PCN # ESW490-44 – Thyristor & Diode TO247_ISO247_PLUS247_ISOPLUS247 Packaging Location Transfer

Product/Process Change Notice (PCN)

PCN#: ESW490-44 **Date:** June 28th, 2022

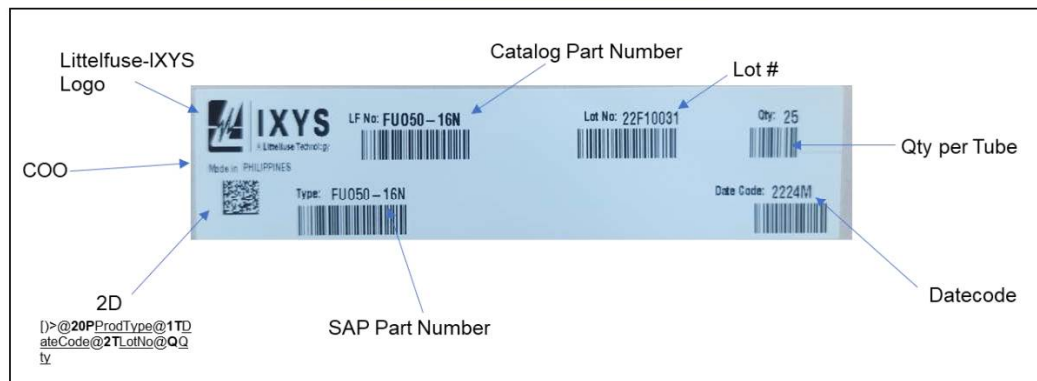
- 1) **Silicon Die:** No change
- 2) **Backend Assembly Bill of Materials:** No change
- 3) **Backend Assembly Process Flow:** No change
- 4) **Backend Assembly Equipment:** Equal or better
- 5) **Marking & Labeling:** Yes. Changes pls refer to below details.
